REMARKS/ARGUMENTS

This Amendment is responsive to the Office Action mailed March 4, 2004.

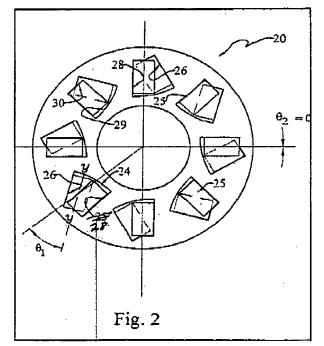
Moreover, Applicant proposes to amend Fig. 2 to change reference numeral "25" to -- 28 --, as shown in the insert. This merely makes the drawing consistent with the specification.
